From: Charlotte Burrows on behalf of Planning.Responses
Sent: 14 September 2017 13:44
To: Planning Scanning
Subject: FW: FG/108/17/DOC - Condition 4 Internal Noise levels - Ferring
Attachments: JSL2159_101B.pdf

Subject: FG/108/17/DOC - Condition 4 Internal Noise levels - 1 Bennett Gardens, Ferring

Land at Ferring
Worthing

Site Boundary Plan

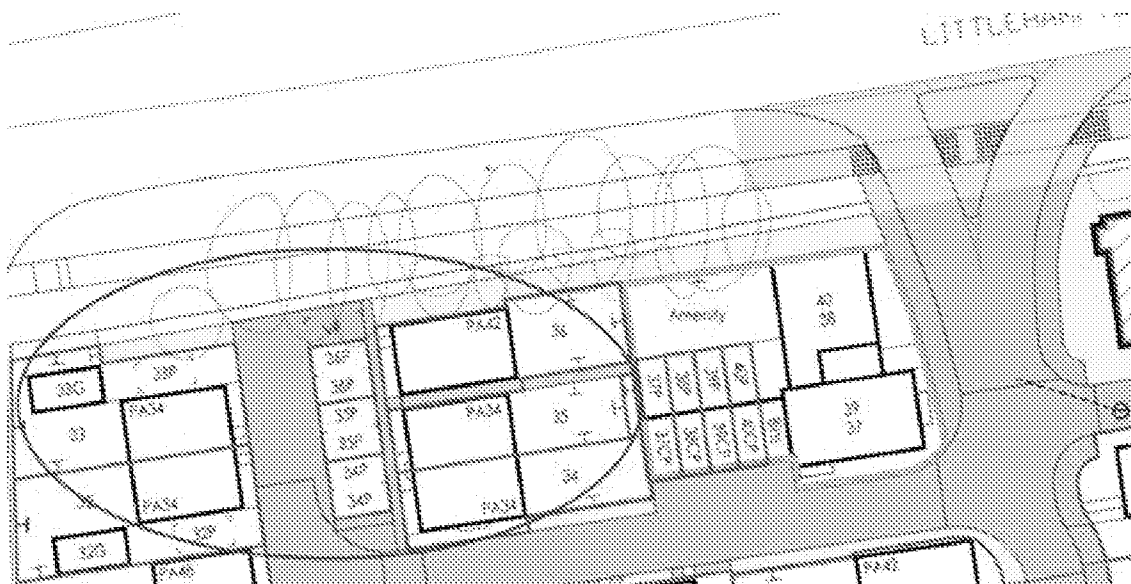
My question was regarding the remaining units which as you will see in the below image have only plot 36 adjacent to the a259 with 35 and 34 protected by 36.

We intend on carrying out the testing in 2 weeks time so to avoid any disruption I wanted to check if this was an error and instead the condition should state 33 and 36 or if you would like me to carry out testing to the 3 units listed in the condition?

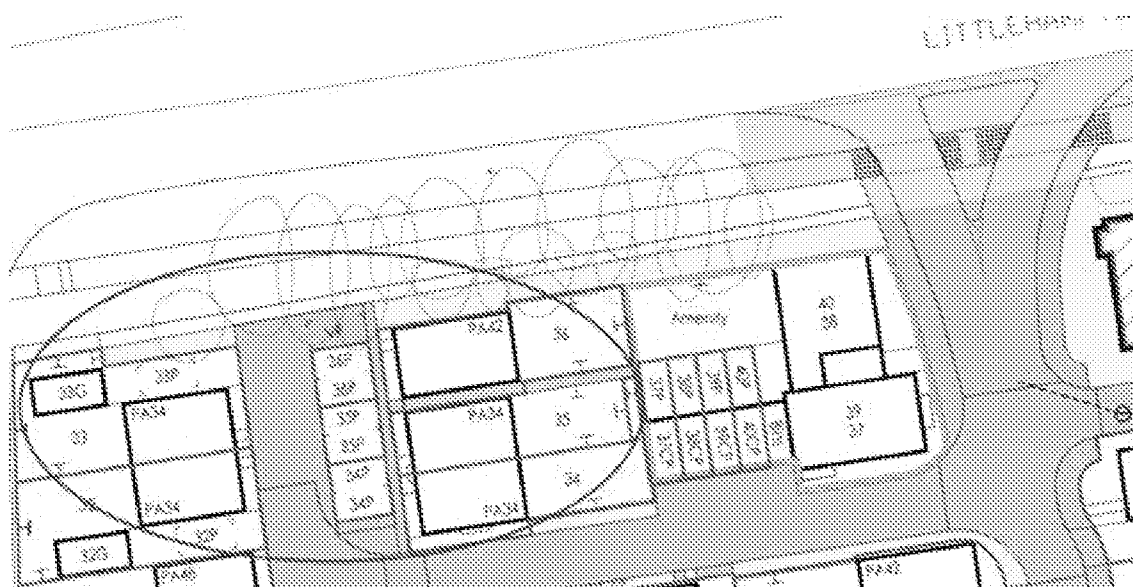
Going forward we still are due to test more plots alongside the A259. The condition does ask for testing of 3 plots (34-36) however only one of those plots front on to the A259 and we intend on testing the two left on site that do (33 and 36). Please see the exert of the site below for reference.

Can you please confirm that you would like Taylor Wimpey to test plots 33 and 36 instead of what is stated in the condition as 34-36 that contains two units that are shielded by plot 36 or if you would like us to test all 3 units as stated?
